# Work Order ID 89182

Item Name: Crosstube Aft

DRAWING NO. D412-664-243	TITLE CROSSTUBE ASSEMBLY (412 HI AFT)	REV. E	<b>DART AEROSPACE LTD ENGINEERING ORDER</b>		D.E.O. NO. D412-664-243-E-1	SHEET NO. SHEET 1 OF 2	SCALE NTS
DRAWN	CHECKED	MFG. APPR.	APPROVED		DE APPR.		
DATE 11.03.31	DATE 11/03.31	DATE 11.03.31	DATE 11/03.31		DATE 11.03.31

DRAWING NO. D412-664-243	TITLE CROSSTUBE ASS'Y (412 HI AFT)	REV. E	DART AEROSPACE LTD ENGINEERING ORDER		D.E.O. NO. D412-664-243-E-2	SHEET NO. SHEET 1 OF 1	SCALE NTS
DRAWN <i>MP</i>	CHECKED <i>ASS</i>	MFG. APPR. <i>RE</i>	APPROVED <i>MP</i>		DE APPR. <i>MP</i>		
DATE 11.09.07	DATE 11.09.19	DATE 11.09.19	DATE 11.09.19		DATE 11.09.19

**D412-664-243  
ASSEMBLY DETAIL**

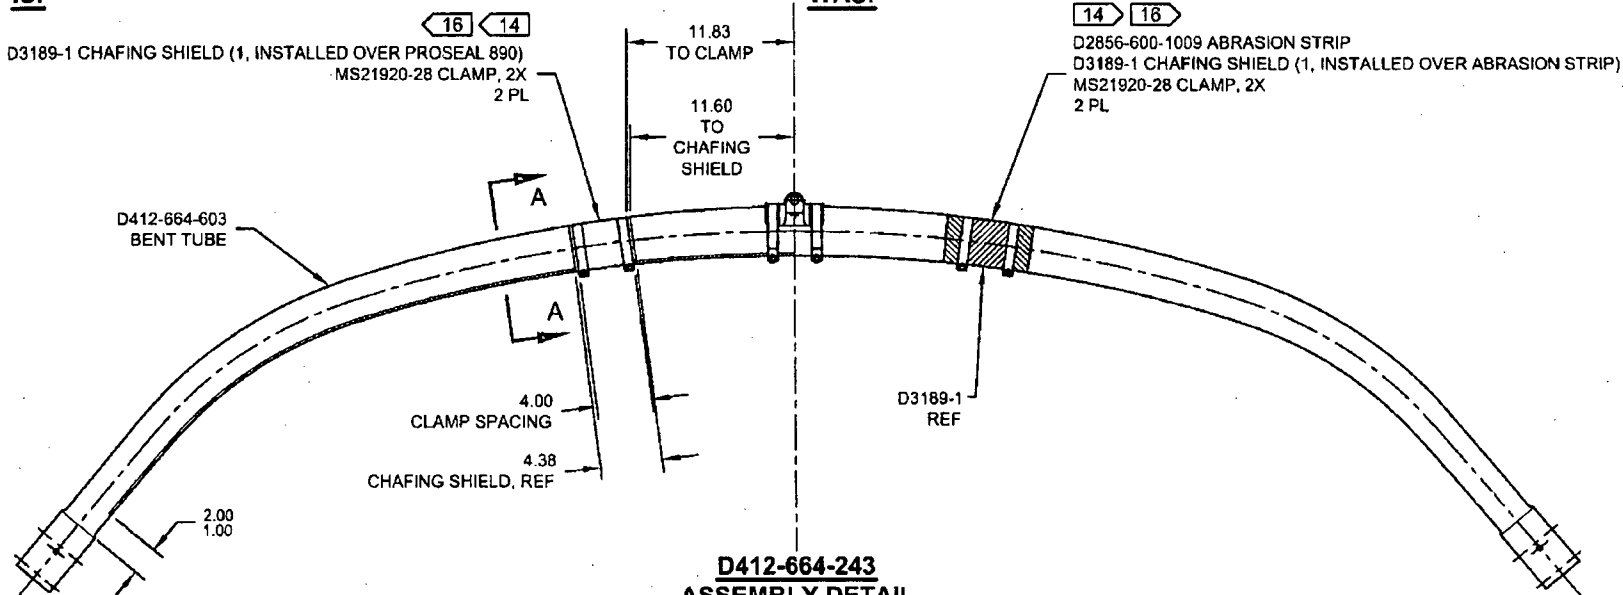
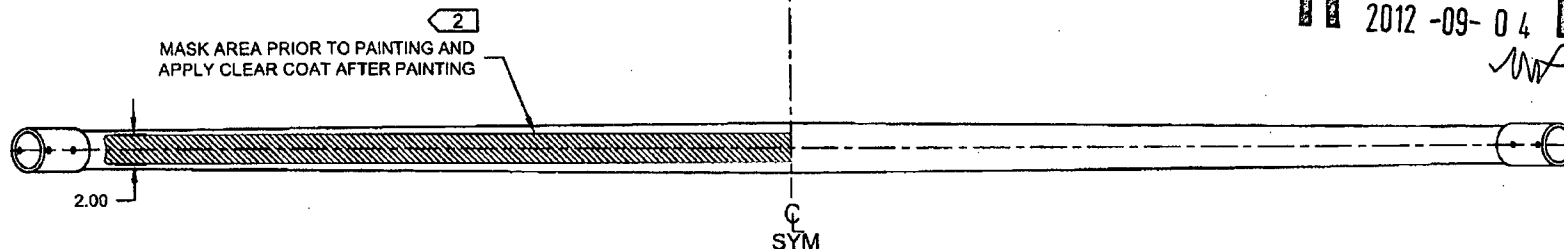
DRAWING NO. D412-664-243	TITLE CROSSTUBE ASSEMBLY (412 HI AFT)	REV. E	DART AEROSPACE LTD ENGINEERING ORDER	D.E.O. NO. D412-664-243-E-4	SHEET NO. SHEET 2 OF 3	SCALE NTS
DRAWN <i>GP</i>	CHECKED <i>[Signature]</i>	MFG. APPR. <i>[Signature]</i>	APPROVED <i>[Signature]</i>	DE APPR. <i>[Signature]</i>		
DATE 12.08.21	DATE 12.08.27	DATE 12.08.29	DATE 12.08.29	DATE 12.08.29

MASK AREA PRIOR TO PAINTING AND  
APPLY CLEAR COAT AFTER PAINTING

**SECTION A-A**  
CHAFING SHIELD DETAIL  
VIEW ROTATED, NOT TO SCALE

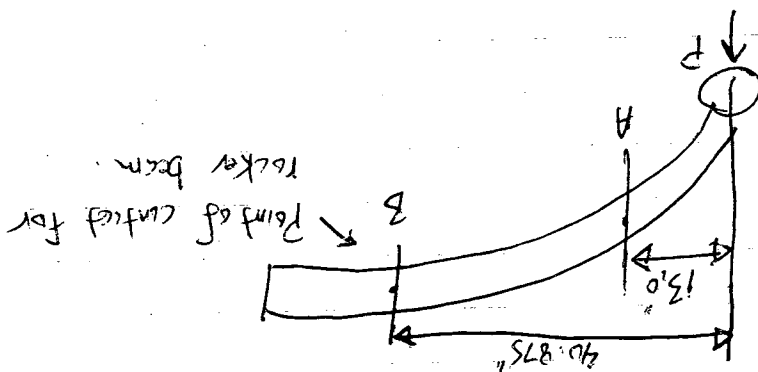
DRAWING NO. D412-664-243	TITLE CROSSTUBE ASSEMBLY (412 HI AFT)	REV. E	DART AEROSPACE LTD ENGINEERING ORDER		D.E.O. NO. D412-664-243-E-4	SHEET NO. SHEET 3 OF 3	SCALE NTS
DRAWN <i>MP</i>	CHECKED <i>MP</i>	MFG. APPR. <i>MP</i>	APPROVED <i>MP</i>		DE APPR. <i>MP</i>		
DATE 12.08.21	DATE 12.08.27	DATE 12.08.29	DATE 12.08.29		DATE 12.08.29
